ADDENDUM #2
 02/22/2018

A NEW REMODEL PROJECT FOR:
SHERWOOD HIGH SCHOOL
 16956 SW MEINCKE ROAD
 SHERWOOD, OR

DRAWN BY:	RWL
CHECKED BY:	SWM
DATE:	1-30-18
TITLE:	PARTIAL FLOOR PLUMBING PLAN
SCALE:	1/8" = 1'-0"

SHEET NO:	P-1.3
	3 OF 4

1 PARTIAL FLOOR PLUMBING PLAN
 P1.3 SCALE: 1/8"=1'-0"

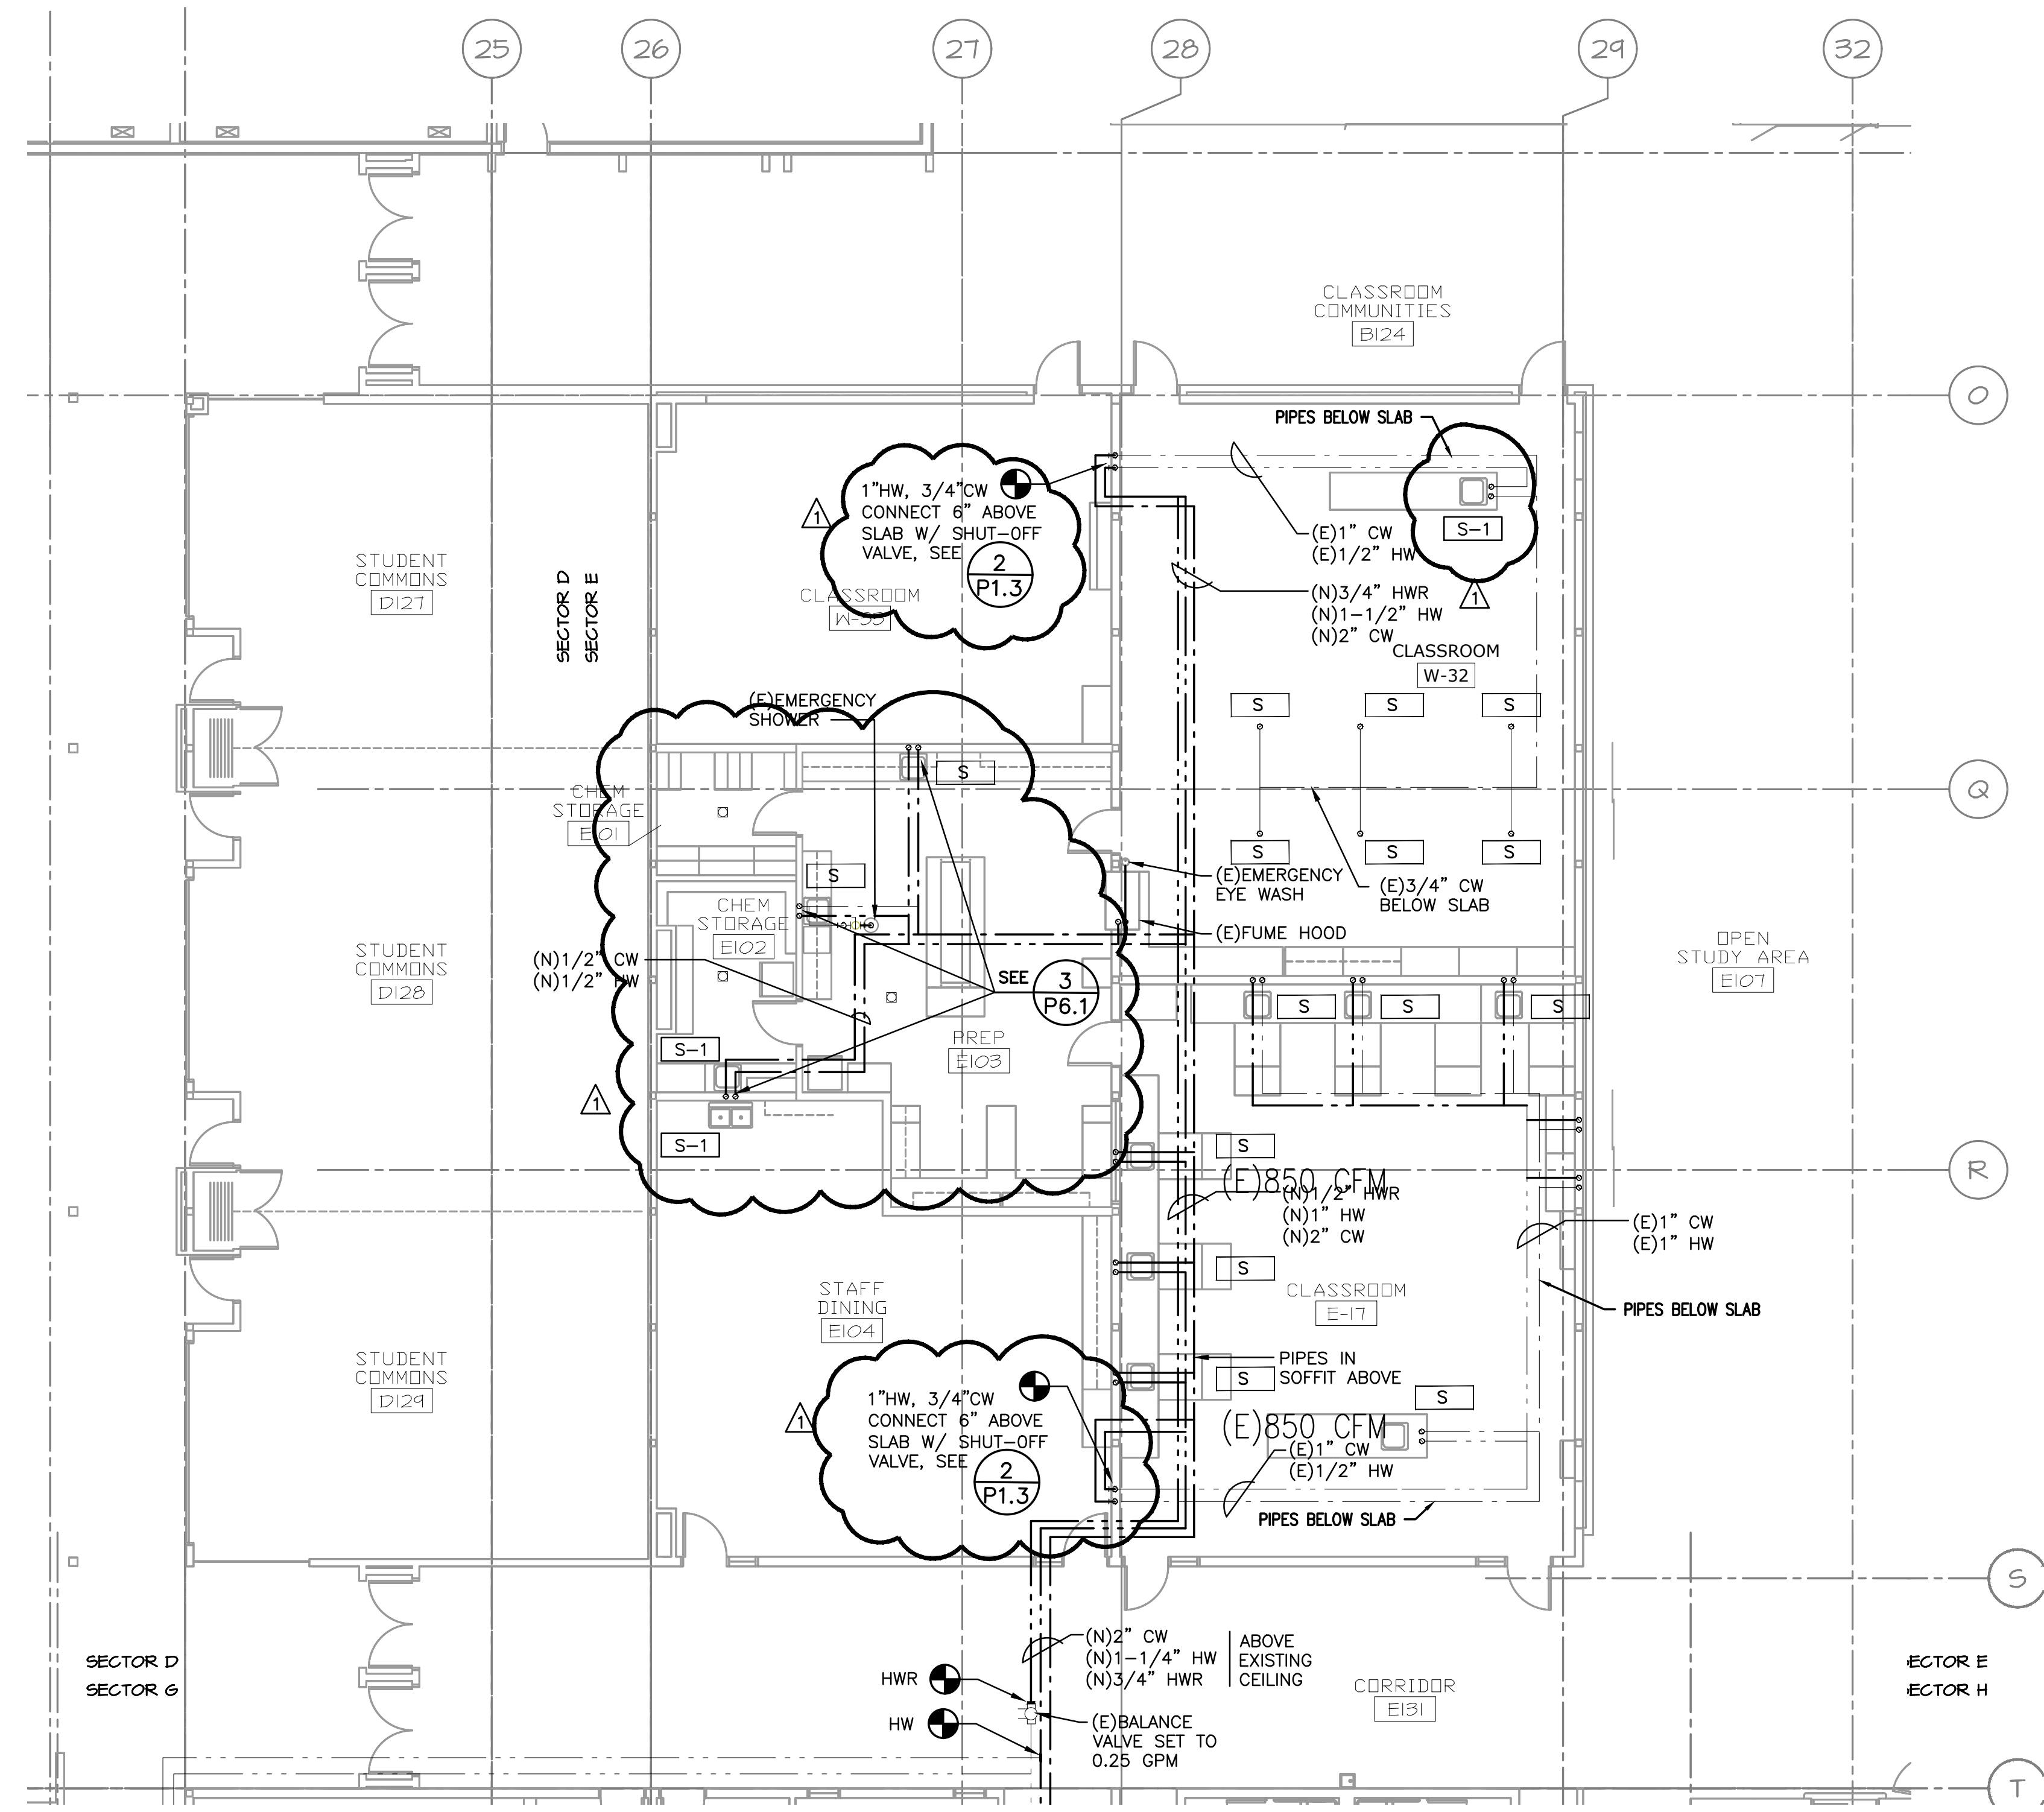
- REPLACE STUB-OUT, ANGLE-STOP AND FLEXIBLE CONNECTION.
- PLAN NOTES:**
- (A) — CONNECT TO EXISTING CLOTHES WASHER SUPPLY.
 - (B) — CONNECT TO EXISTING CW SUPPLY TO TRAP PRIMER. PROVIDE NEW PRIMING VALVE. SEE SPECS FOR APPROVED TYPE.

- (C) — PROVIDE OVERFLOW DRAIN AT ROOF. ROUTE OVERFLOW LEADER AS HIGH AS POSSIBLE. ALL EXPOSED PIPE TO BE PAINTED.
 - (D) — ROUTE OVERFLOW DRAIN DOWN INSIDE WALL. PROVIDE OVERFLOW NOZZLE AT APPROX 12" ABOVE FINISHED GRADE

- (E) — REPLACE EXISTING GALVANIZED PIPE FROM EXISTING SHOWER VALVE TO EXISTING SHOWER HEAD. VALVE AND HEAD TO BE RE-USED. PROVIDE PIPE SUPPORT PER SPECIFICATIONS.

- (F) — ROUTE PIPING EXPOSED ON WALL TO EXISTING MIXING VALVE. SEE FOR TYPICAL PEX WALL DROP. **1 P6.1**
 - (G) — REMOVE AND REINSTALL (E) COPPER WATER LINES IN THIS AREA FOR STRUCTURAL CONTRACTORS TO ADD SEISMIC CLIPS @ TOP OF WALL. COORDINATE W/ FRAMER FOR EXTENT OF WORK.

- (H) — EXISTING FLOOR DRAIN(S) IN MECHANICAL MEZZANINE ABOVE. SNAKE DRAIN, REPLACE COVER, TEST PRIMER AND CONFIRM OPERATION. REPORT ANY DEFICIENCIES TO ARCHITECT.
